# Access Compliance Report

## Public Rights-of-Way

### (Curb Ramps)

Intersection ID: 16160	Main Street: MARSH_RD	Cross Street: WRISTON_PL	Location: NE
ADA ID: C70BBA10441F	Ramp Type: Perp	Initial Pass/Fail: Fail	Overall Compliance: No
Severity Score: 25			
Codes/Mitigation Info/Possible Solution		Field Measurements/Component Compliance

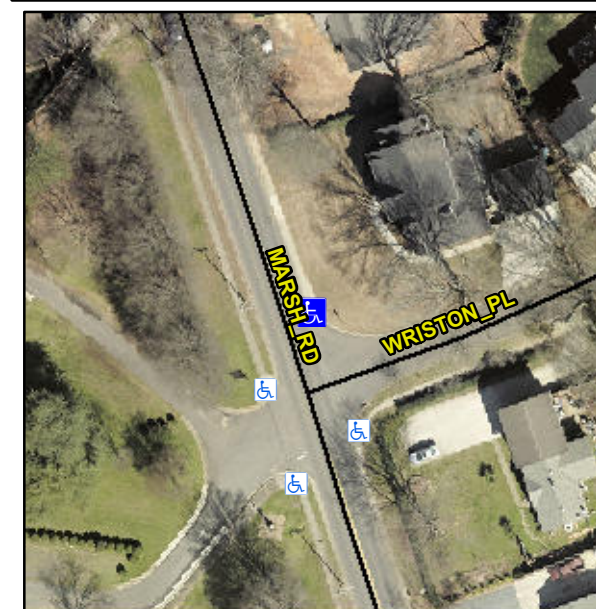
**Not Found, R304.5.3**

Compliance	Description	Data	Compliance	Description	Data
N/A	Ramp Length (in)	60.0	Yes	Ramp Slope (%)	7.7
Yes	Ramp Width (in)	48.0	No	Ramp XSlope (%)	7.7
N/A	Flare Type LT	N/A	N/A	Flare Type RT	N/A
N/A	Flare Slope LT (%)	N/A	N/A	Flare Slope RT (%)	N/A
N/A	Flare Traversable LT?	N/A	N/A	Flare Traversable RT?	N/A
N/A	Landing Length (in)	N/A	N/A	DWS Provided?	N/A
N/A	Landing Width (in)	N/A	N/A	DWS Contrast?	N/A
N/A	Landing Slope (%)	N/A	N/A	DWS Length (in)	N/A
N/A	Landing X Slope (%)	N/A	N/A	DWS Full Width?	N/A
N/A	Landing Curb? (Y/N)	N/A	N/A	DWS Offset (in)	N/A
N/A	Shared Landing?	N/A			
N/A	Gutter Ponding?	N/A	N/A	Gutter Slope (%)	N/A
N/A	Gutter Lip Ht (in)	N/A	N/A	Gutter X Slope (%)	N/A
N/A	Painted X Walk1?	No	N/A	Painted X Walk2?	N/A
	X Walk 1 Direction	To SW		X Walk 2 Direction	N/A
N/A	X Walk 1 Width (in)	N/A	N/A	X Walk 2 Width (in)	N/A
	X Walk 1 Slope (%)	6.1		X Walk 2 Slope (%)	N/A
	X Walk 1 X Slope (%)	0.6		X Walk 2 X Slope (%)	N/A

**Remove & Replace Entire Ramp.**
